Access Compliance Report Public Rights-of-Way (Curb Ramps)

Intersection ID: 12344 Main Street: REMOUNT_RD Cross Street: GREENLAND_AV Location: NW **Overall Compliance: No** ADA ID: 4E0BB2553FAA Ramp Type: Perp Initial Pass/Fail: Fail **Severity Score:** 12.5

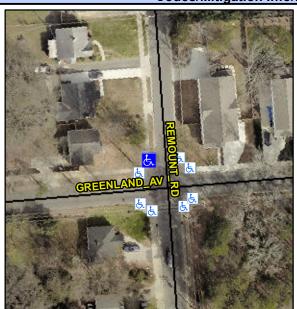
COSIBIC COIGUION	
Possible Solutions:	C
Remove & Replace Entire Ramp.	N/
	Ye
	N/
	N/
	N/
	N/
Surveyor Notes:	N/
N/A	N/
	N/
	N/
	N/
PROW/ADA:	N/
Not Found, R304.2.2	N/
	N/
	N/
	N/
